RAI Volume 3, Chapter 2.2.1.4.2, First Set, Number 2:

RAI Volume 3, Chapter 2.2.1.4.2, First Set, Number 3:

Figure 1. Schematic Depiction of Borehole (map view) with a Bisecting Fracture

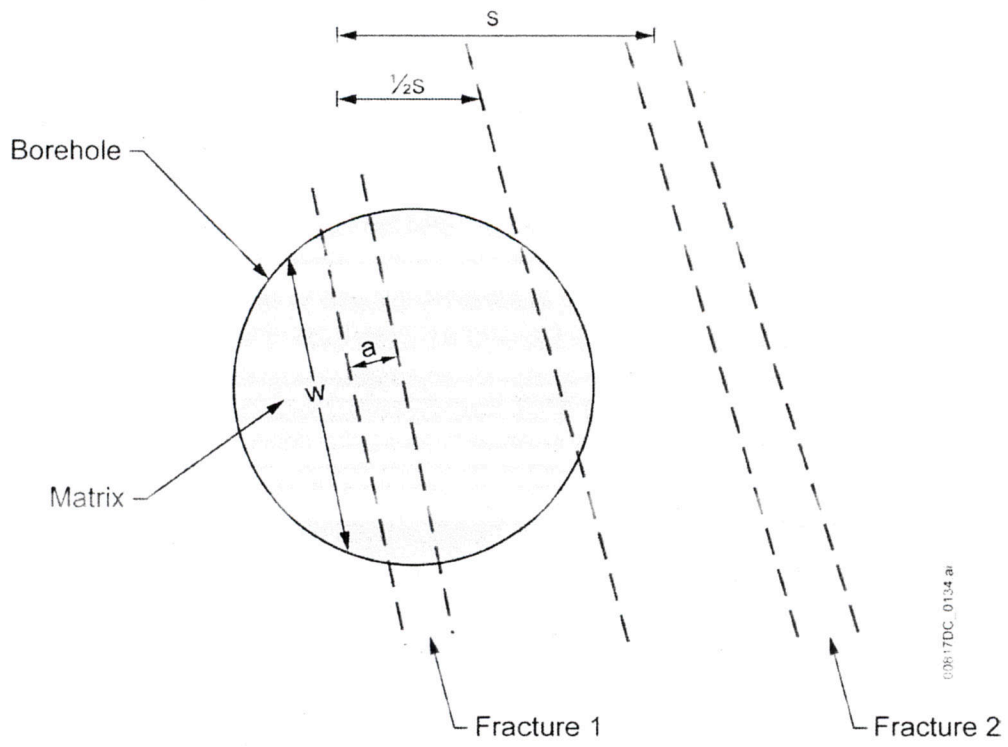
Clarify the technical basis for delay of radionuclide transport due to matrix diffusion in the borehole.

Basis: Advective flow of water in the borehole potentially results in very short travel times (e.g., on the order of a few years) in the borehole when fracture-matrix interactions are ignored (see section 2.4.3.3.5.1 of the SAR, page 2.4-316). The SAR suggests that sorbing radionuclides are delayed significantly due to matrix diffusion (Figure 2.4-170). But the supporting information does not clearly explain the basis for how the relatively slow matrix diffusion process has such a significant effect given the very short travel times and the limited time over which the matrix diffusion process can occur. The staff needs this information to determine compliance with 10 CFR Part 63.114.

In the TSPA model, radionuclide transport through the borehole is modeled using the GoldSim pipe pathway element. The conceptual model of the borehole is depicted in Figure 6.7-6 of *Total System Performance Assessment Model/Analysis for the License Application* (SNL 2008), which is reproduced as Figure 1. Vertical transport down the unsaturated fracture is represented as two parallel plates with no infill between the plates. The distance between the plates is the average fracture aperture for the rock units comprising the devitrified tuff of the repository horizon, which includes the host-rock units TSw34, TSw35, and TSw36, with the width of the plates determined by the size of the borehole. Molecular diffusion occurs between the fracture and borehole rubble surrounding the fracture, and then through the porous medium. Radionuclide decay and decay product growth occur in both the fracture and the matrix. Although no sorption is modeled in the fractures for any radionuclide, sorption is modeled in the matrix. Consistent with the treatment in the three-dimensional unsaturated zone transport model, the partition coefficients for sorption in the matrix are those for devitrified tuff. The input parameters for the borehole transport model are defined in Table 1.

- w = fracture width
- s = fracture spacing
- a = fracture aperture
- $\frac{1}{2}s$ = diffusion length between fracture and matrix
- Borehole = Drill Patch Area = 0.0324 m²

Figure 1. Schematic Showing the Conceptualized Flow Processes near Perched Water Zones within a Typical West-East Cross Section of the Site-Scale Unsaturated Zone Flow Model Domain

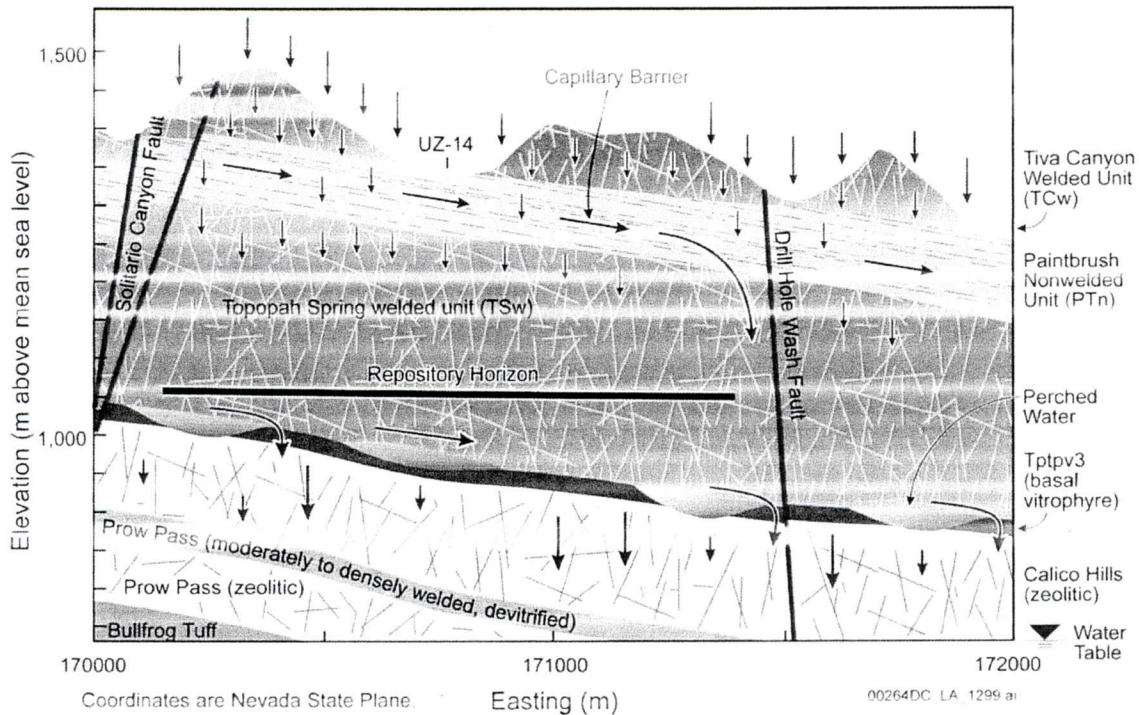
Address the impact on overall performance of drilling through the perched water below the repository to the saturated zone, considering the volume and areal extent of the perched water and the potential effect on the transport of radionuclides within the unsaturated zone.

Basis: DOE has included perched water in its TSPA as a feature that deflects radionuclide transport paths laterally to faults, then down to the saturated zone. The human intrusion scenario (i.e., borehole to the saturated zone) could result in a borehole penetrating the perched zone and thereby potentially affecting the pathway of radionuclides within the perched zone down to the saturated zone (i.e., radionuclides released from breached waste packages, which are transported to a perched zone, could subsequently enter the borehole and move down the borehole to the saturated zone). The staff needs this information to determine compliance with 10 CFR Part 63.322.

Perched water in the Yucca Mountain region tends to occur when units with well-connected fracture porosity, such as in the Topopah Spring welded unit (TSw), overlie low-permeability or poorly fractured units such as the basal vitrophyre of the lower TSw, or the hydrothermally altered zeolitic Calico Hills unit (CHn). Figure 1 (SAR Figure 2.3.2-5) shows a cross section of these hydrogeologic units and a conceptualization of flow patterns near perched water bodies, indicating lateral fracture flow in the TSw above the perched zones. Although flow does occur through the fractures of the areally extensive basal vitrophyre, it is limited because the fractures are frequently filled with alteration products that tend to block flow.

Just below the repository but above the perched water, the gently eastward dipping TSw has low porosity and widespread fracturing typical of densely welded tuffs, which results in fracture-dominated advective-dispersive transport (Figure 1). The strongly altered northern part of the CHn unit, composed of zeolites and clays with low permeability and poorly developed, sparsely connected fractures, results in a low permeability layer. Because of the low permeability, water flux to the CHn unit and just above the perched zone may be diverted laterally, down-dip to the east towards the faults, which act as main pathways for fast flow and transport in the unsaturated zone. A human intrusion borehole through the perched zone may act as a high permeability fast
